Sandy City Planning Commission

Agenda

April 5, 2018

To: Planning Commission
From: Community Development Department
Subject: Lyon - Review of 30% Slope - Pepperwood Ph 9, Lot 915 SPEX-02-18-5367
 33 Lone Hollow (approx. 11350 South 2500 East)
 [Pepper Dell, Community #28]

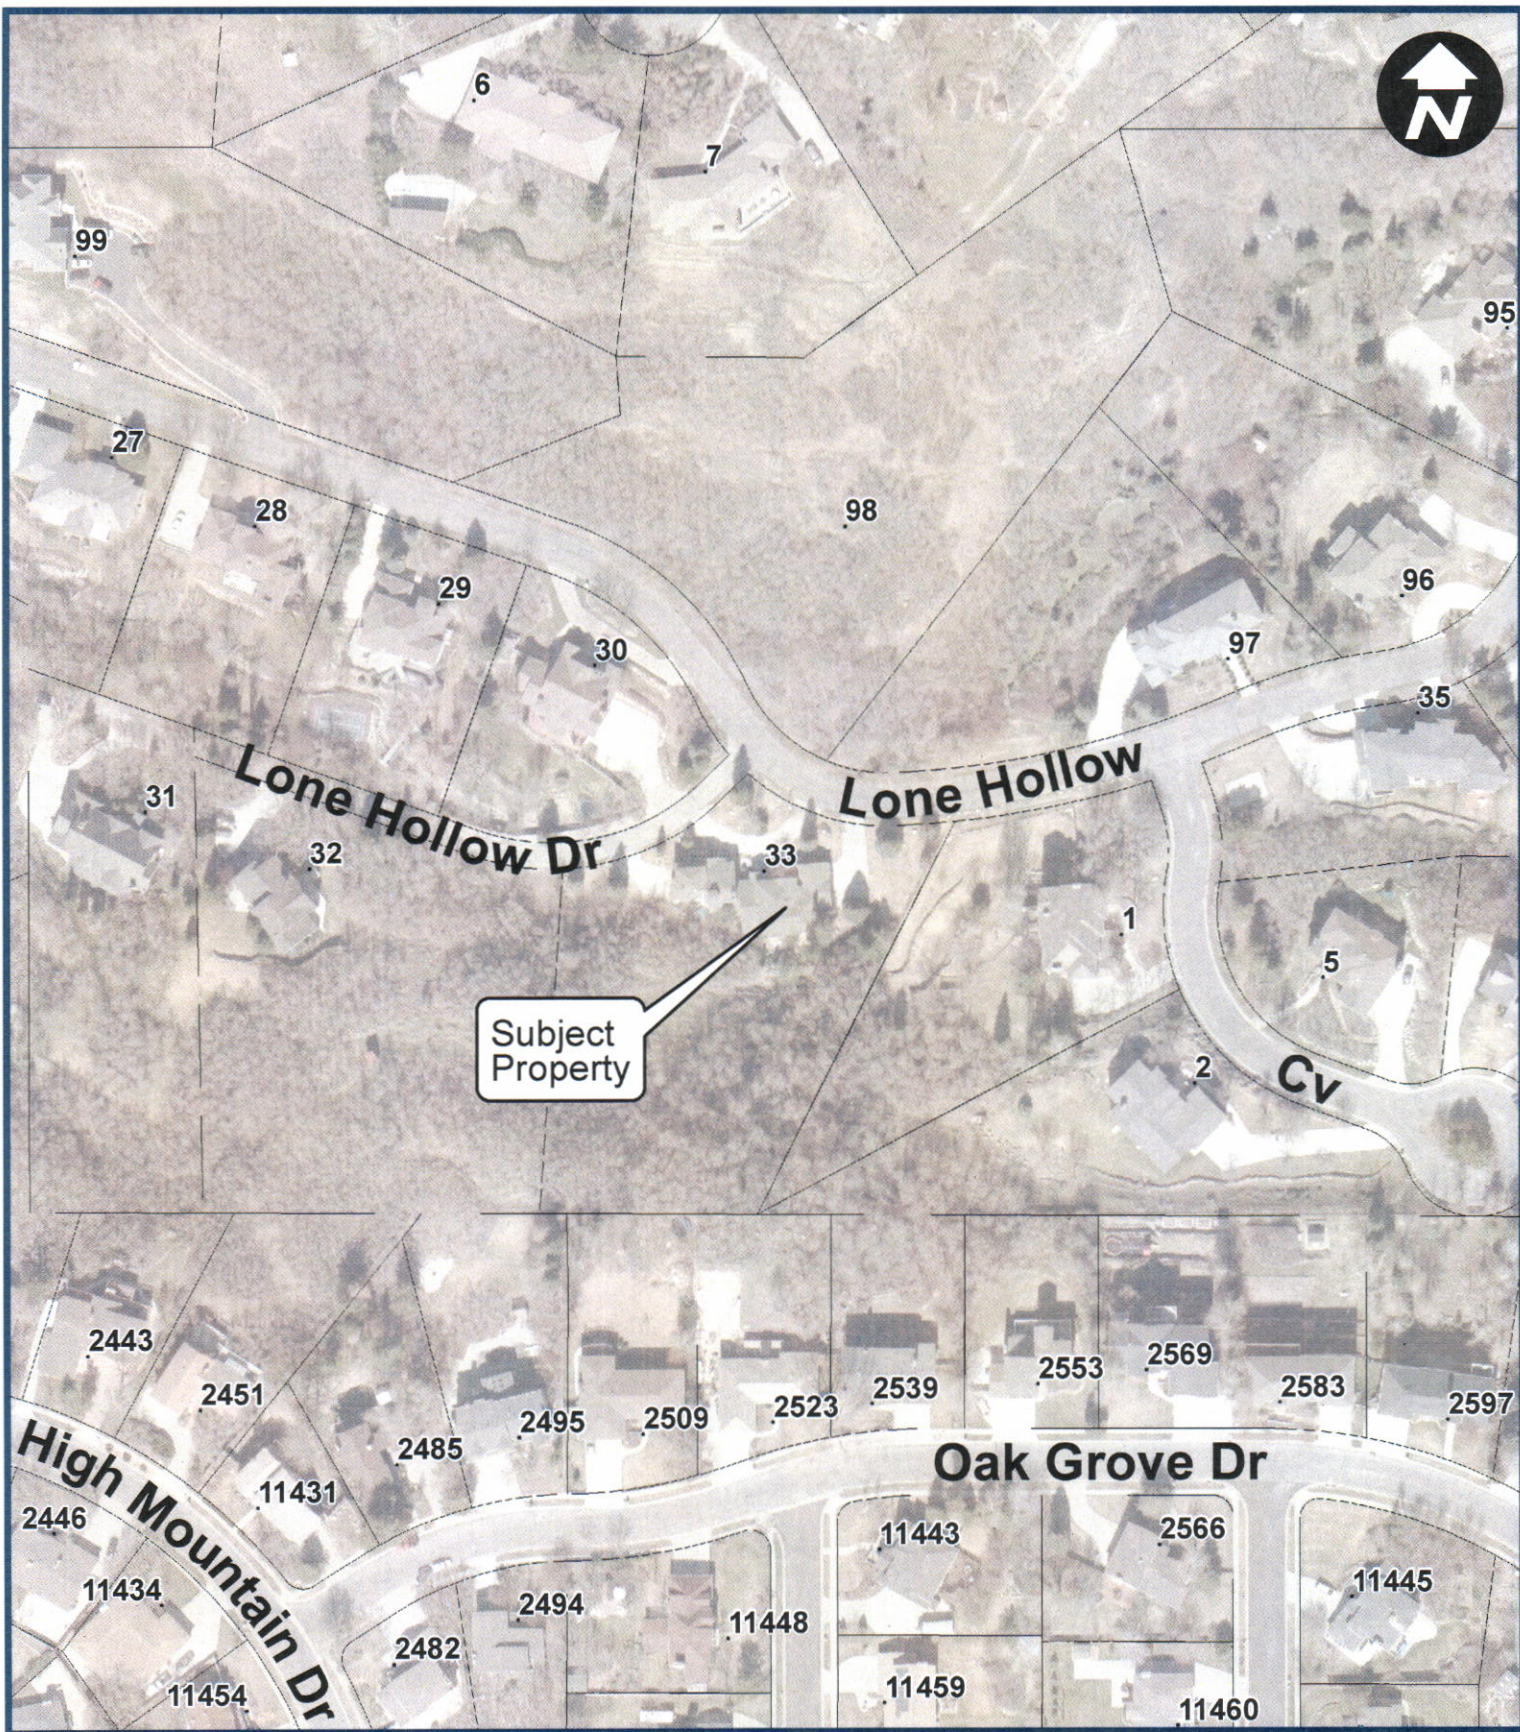
There is a note on the plat that contains the Planning Commission's Conditions of Approval. Condition #14 prohibits grading, cuts, fills, terracing or vegetation removal on slopes of 30% or greater. The Planning Commission, upon receiving a recommendation from the City Engineer, can approve such alterations. Mr. Lyon has approached the City with this request to alter an area that was designated as 30% slope on the plat. The applicant provided a new field survey (attached) along with an engineered site plan (see Site Plan). This illustrates the platted 30% slope area versus the actual areas of 30% slope. It also shows the other site improvements the applicant is desirous to make including a retaining wall at the edge of the 30% slope line, pools, patio, etc. (see attached Pool and Retaining Wall Design).

The City Engineer has reviewed the request and the materials provided by the applicant thoroughly. After this review and a site visit, he has provide a positive recommendation to the Planning Commission to approve the request of Mr. Lyon (see the attached Public Works Letter). He has found that a portion of the area designated on the plat as 30% slope on lot 915, does not match the field survey as shown on the site plan.

Planning Staff has only one concern regarding the proposed retaining wall. Most of the wall is five (5) feet or under, but there are portions of the wall that go up to eight (8) feet in height, particularly in close proximity to the property line. The development code requires that any wall located along a property line that exceeds five (5) feet in height must set back five (5) feet between the segmented retaining wall. In section 15A-28-08 of the Land Development Code it states:

Staff believes that the applicant can modify this design to comply with the code without need of an additional special exception. However, the Planning Commission is empowered with the ability to grant it per the above code citation.

Staff asks that the Planning Commission **determine whether an alteration to a designated 30% slope** should be granted for Lot 915 of the Pepperwood Phase 9 Subdivision. If an alteration is granted, it shall be based on the following:

1. That the applicant/builder/owner be required to comply all other applicable requirements related to the Sensitive Area Overlay Zone.
2. That the balance of conditions of approval, as shown on the recorded plat (refer to recorded conditions of approval - S#88-10), remain in force and are not nullified by this action.
3. That the applicant improve the site based on the site plan presented to the Planning Commission and City Engineer, except as required to be modified for the retaining wall design.
4. That portions of the proposed retaining wall be redesigned to comply with development code requirements for additional step back when placed along the property line and are over five (5') in height.
5. That the applicant obtain the necessary building permits for construction of the proposed retaining walls and pools.

JORGENSEN DETACHED GARAGE
1104 FALLBROOK WAY
SANDY UTAH 84094

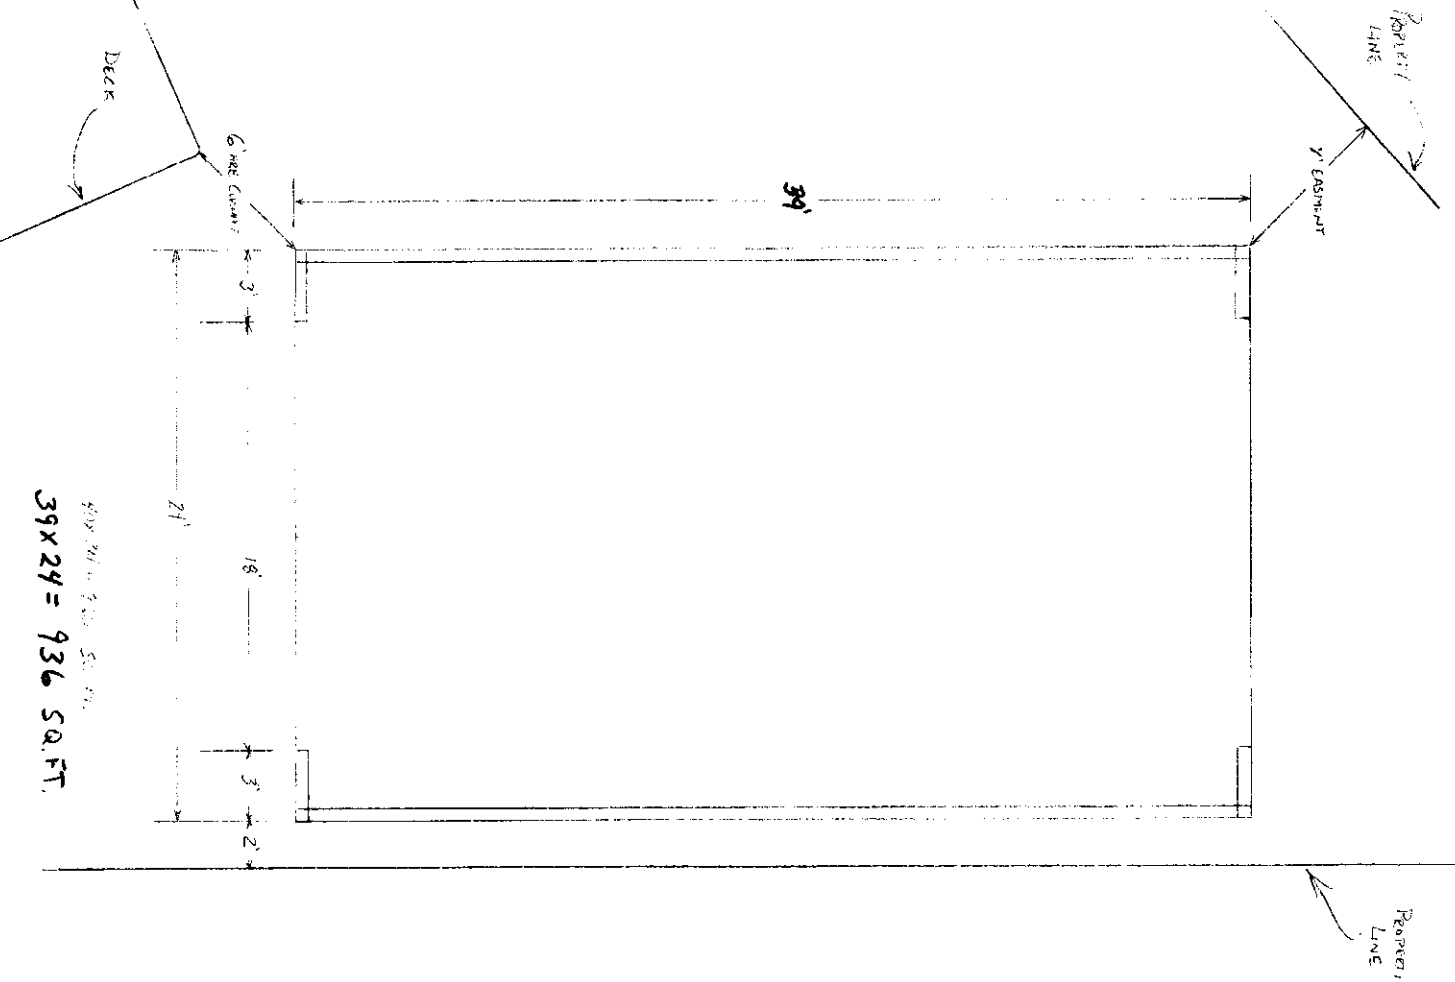
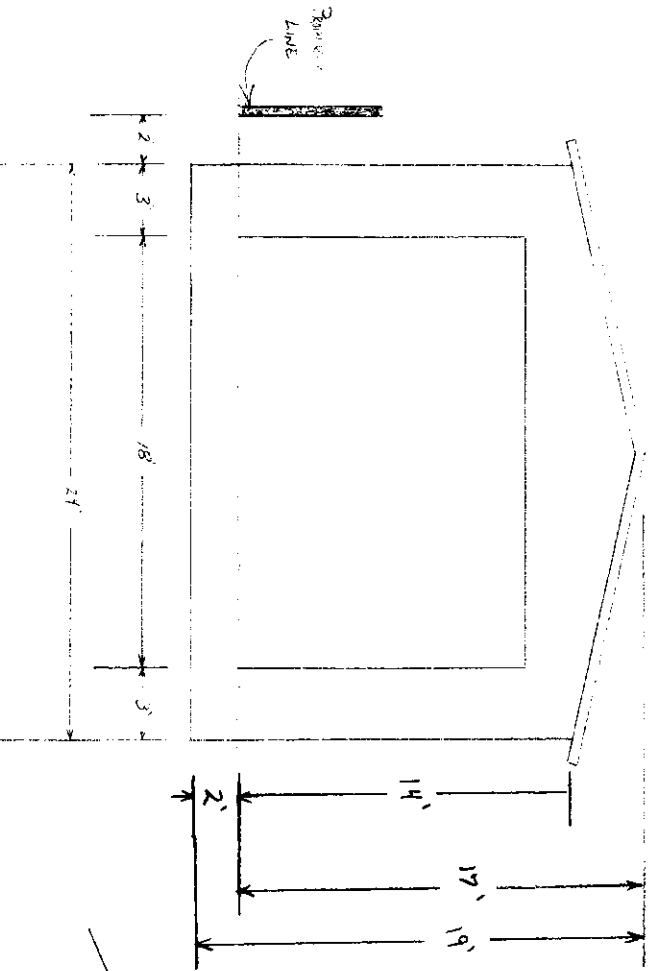
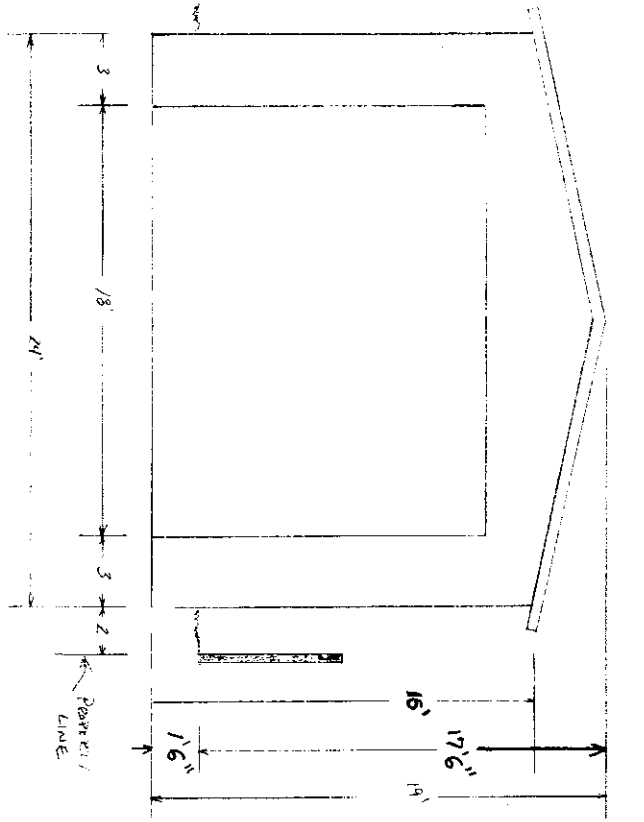
Section 15A-11-02(A3b) of the Sandy City Development Code states that accessory structures exceeding 15 feet in height shall increase the minimum required setback one (1) foot for each one (1) foot of additional height above 15 feet up to the minimum setback for the primary dwelling. The required setback for an accessory structure is two (2) feet, which is what the applicant has requested. However, because the newly proposed garage is 17'3" tall, this section of the code requires that the structure be setback a minimum of 4'3" away from the property line. The Planning Commission has the authority to waive the additional setback requirement if it feels the impacts of the detached garage are minimal on adjacent properties.

Staff asks that the Planning Commission **determine whether an adjustment to the conditions of approval be made** to the approved Conditional Use Permit for Ron Jorgensen for the property located at 1104 E Fallbrook Way. The determination specifically relates to the 5th condition of approval from the findings and conditions of the original application as found below:

1. That the proposed structure comply with all applicable Building & Safety, and Fire & Life Codes.
2. That the applicant be responsible for meeting all provisions of the Sandy City Development Code, and all conditions of approval imposed by the Planning Commission.
3. That any other existing accessory structures on the property be removed prior to the construction of the proposed garage.
4. That the structure have a maximum size of 936 square feet and 17'6" in height measured from average grade to peak of the roof as proposed in the application material.
5. That the structure be setback a minimum of 4'6" from the south side property line. The rear setback must be at least seven (7) feet so as not to encroach on the existing easement, unless the applicant submits waiver letters from all appropriate utility companies. In no case shall the rear setback be less than 4'6" unless the Planning

Commission determines otherwise.

SITE PLAN

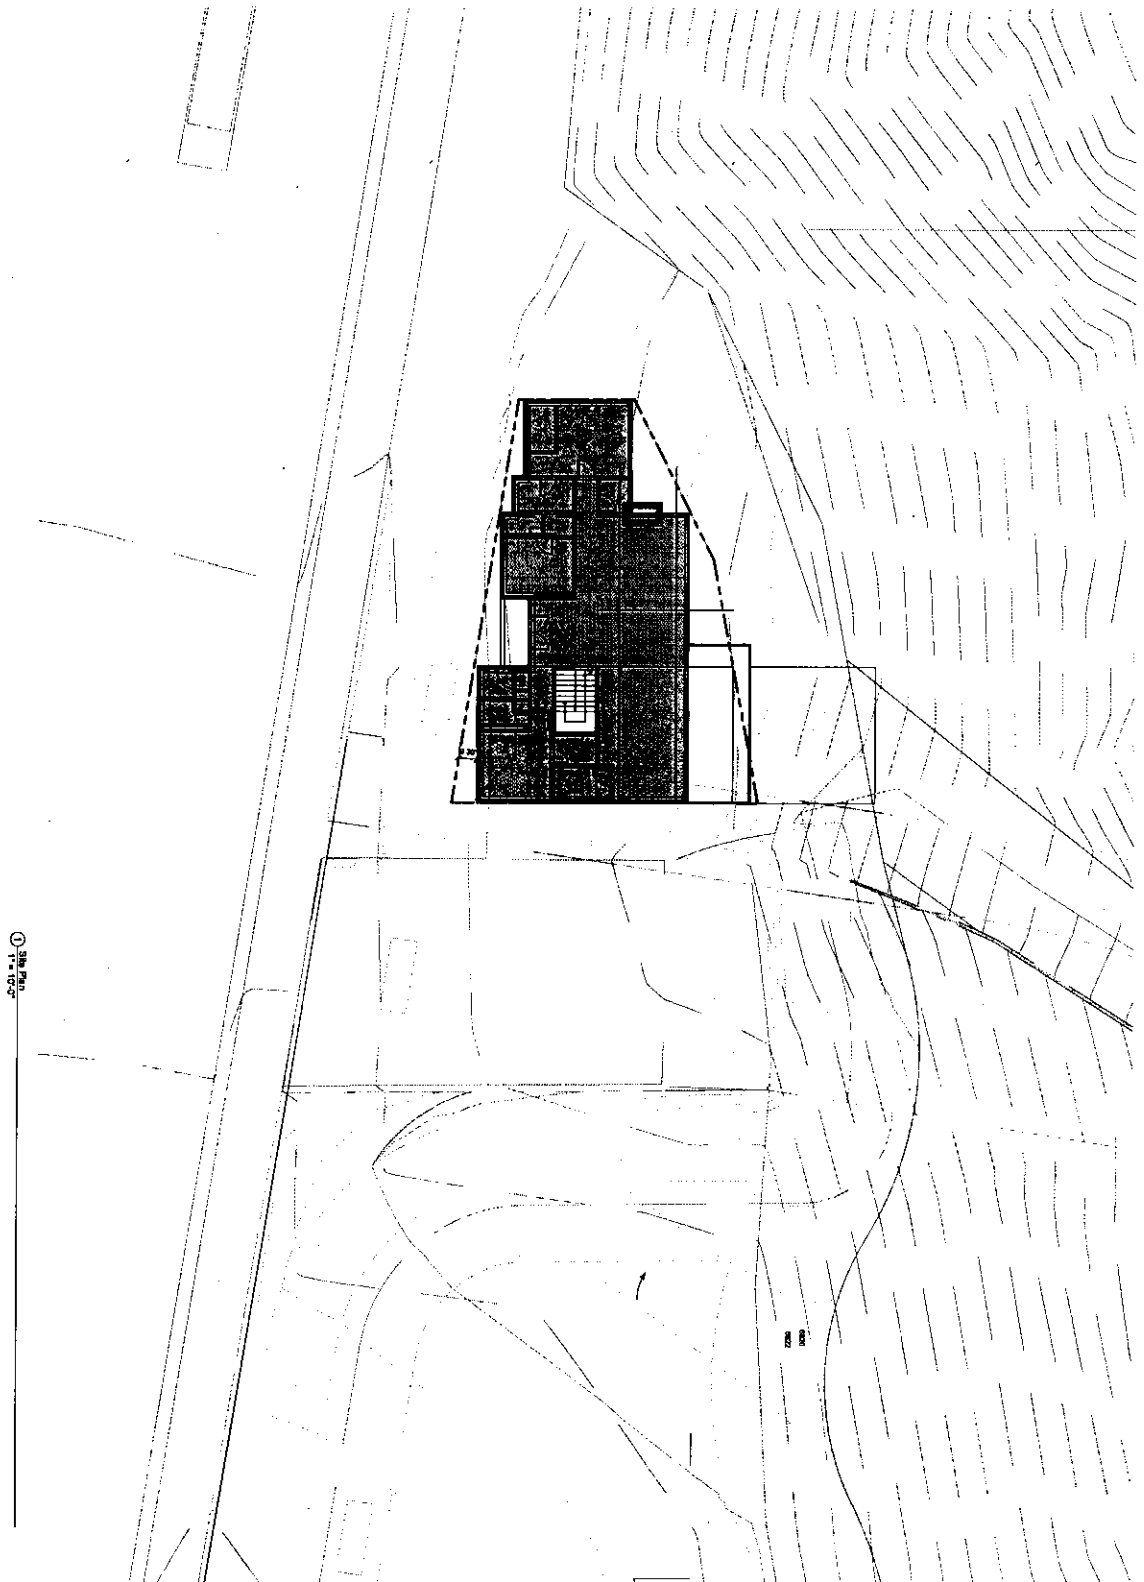
- There were concerns regarding the feasibility of constructing a home within the buildable area of Lot 1 that would meet setbacks, minimum size requirements, and minimum garage requirements. The applicant has had an architect design a home that meets minimum standards of the zone. This home placement plan is attached to this report.

7. That grading, home placement, and vegetation plans be submitted and approved for all lots prior to issuance of a building permit. The grading plan shall include a driveway plan and profile to assure conforming driveway slope. Any down sloping driveway will require approval by the City Engineer.
